## **SUB-SLAB DEPRESSURIZATION SYSTEM INSTALLATION WORK PLAN**

Leica, Inc. Site  
Eggert and Sugar Roads  
Town of Cheektowaga, Erie County, New York  
Site ID Number 915156

**Sub-Slab Depressurization System Installation Work Plan  
for the Former Leica Facility located at the  
Leica, Inc. Site  
Eggert and Sugar Roads  
Cheektowaga, New York  
NYSDEC Site ID 915156**

**Project No. 137015****Revision 1****Prepared for:**

**FIGURE 3  
VAPOR MITIGATION AREAS**

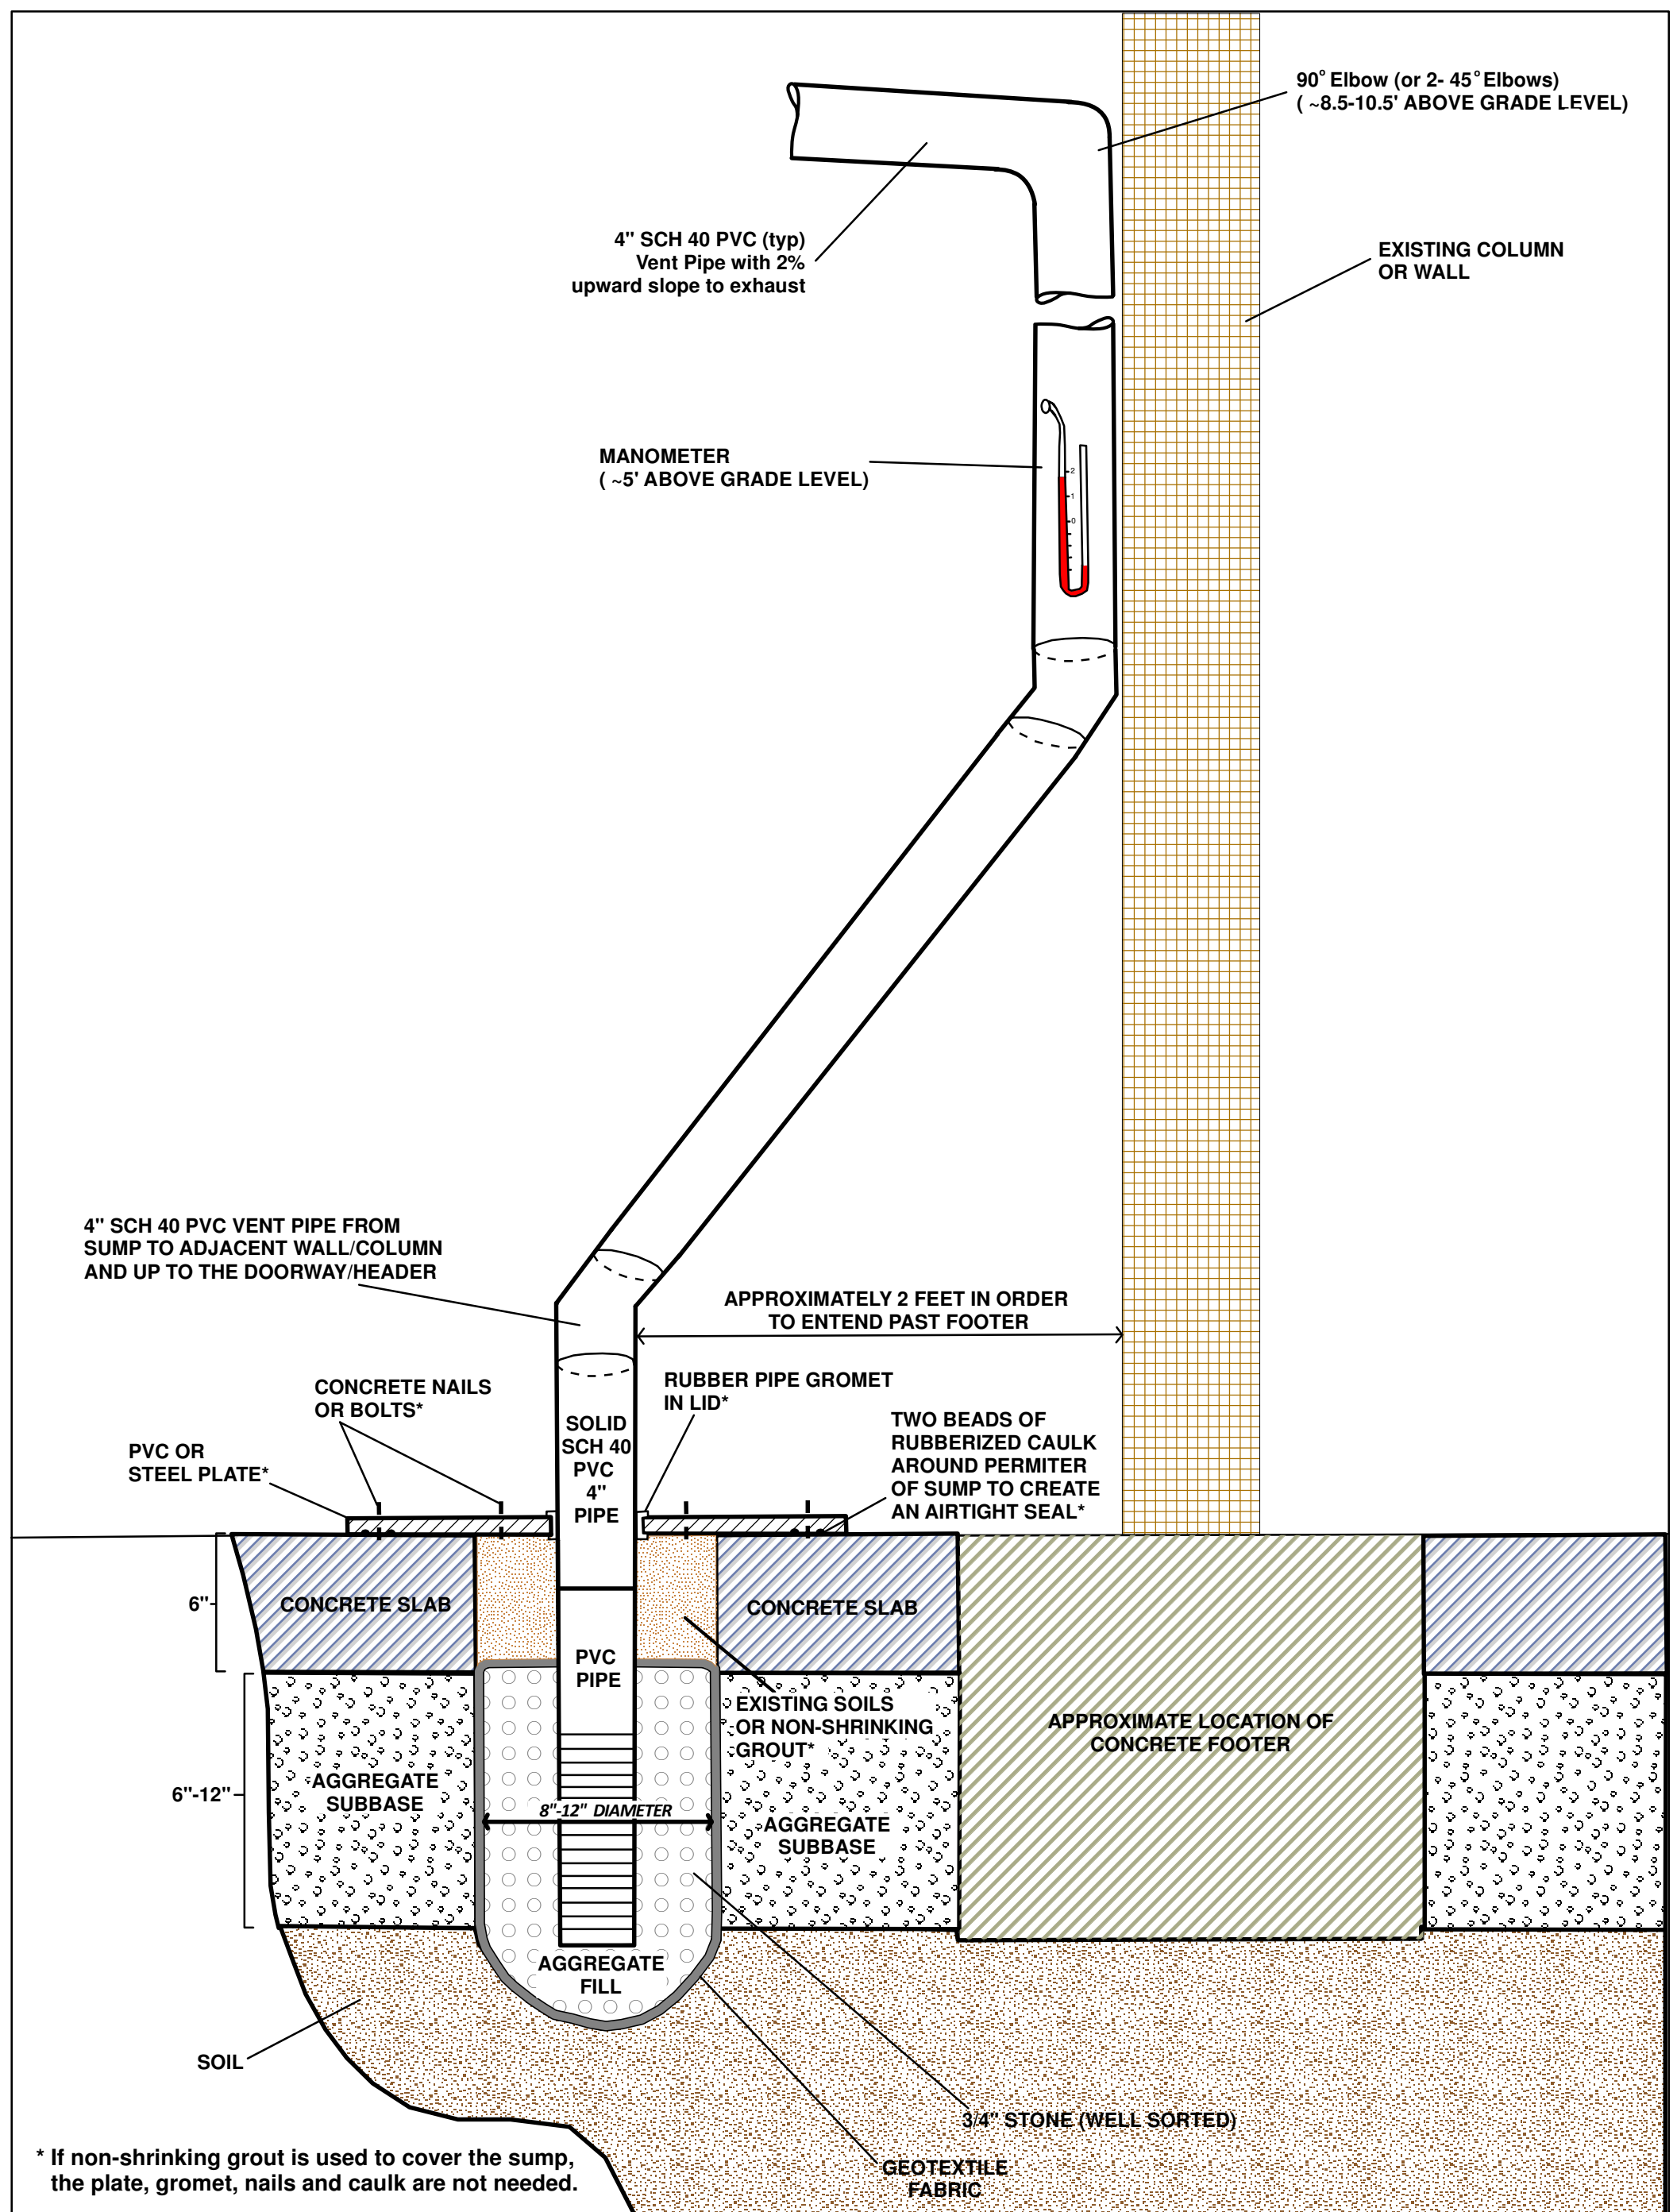
**It is our recommendation that Sam-Son look extremely closely at the proposed vapor extraction well locations and piping locations presented on Figure 3, prior to agreeing to this configuration. Will protection be installed around the piping? How will the piping be sealed as it leaves the building? What dust-suppression techniques will be used when coring the slab?**
